MINOR ALTERATION TO NOTIFIED EXTENT OF AUCKLAND TRANSPORT'S NOTICE OF REQUIREMENT – SOUTH FREQUENT TRANSIT NETWORK NOR 4 – POPES/PORCHESTER INTERSECTION AND APPROACHES

Proposed change to NoR 4

Figure 1 - Comparison between design/designation as lodged (left) and as currently proposed (right)

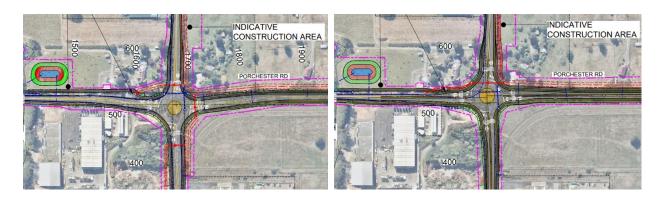
Following lodgement, continued engagement has been undertaken with affected parties. New information identified through this engagement has resulted in identification of a revision to the proposed design, and a consequent change in the likely final designation boundary. The resultant change in designation extent is summarised in Table 2, and is shown in Figure 1.

Address	Approx. land to be designated (m²) – as lodged	Approx. land to be designated (m²) – as proposed under revised design	Change (m²)
296 Porchester Road	5,494	1,851	-3,643
354 Porchester Road	5,702	4,690	-1,012
51 Popes Road	5,295	6,473	1,178
52 Popes Road	8,818	8,557	-261

- New information on the consenting history and existing/planned development on the 296
 Porchester and 354 Porchester sites. This new information was material in the context of the
 Assessment of Alternatives, and the understanding of the existing environment that had informed
 the previous option choices. The team has revisited alignment options where new constraints
 have been identified. A straight alignment is now recommended for Porchester Road in this
 location, where the lodged design showed a slight westward kink;

- New information on the existing and consented stormwater network serving the live-zoned area to
 the west of Porchester Road, and resultant changes in the functional requirements for stormwater
 conveyance and treatment for the road upgrades on the west side of the intersection;

- Refinement of stormwater conveyance options for the east side of Porchester Road as a result of straightening the road alignment; and
- Retesting of intersection layouts from a transport perspective following sensitivity testing
 accounting for the probable removal of the Future Urban Zone (FUZ) to the east of Porchester
 Road.
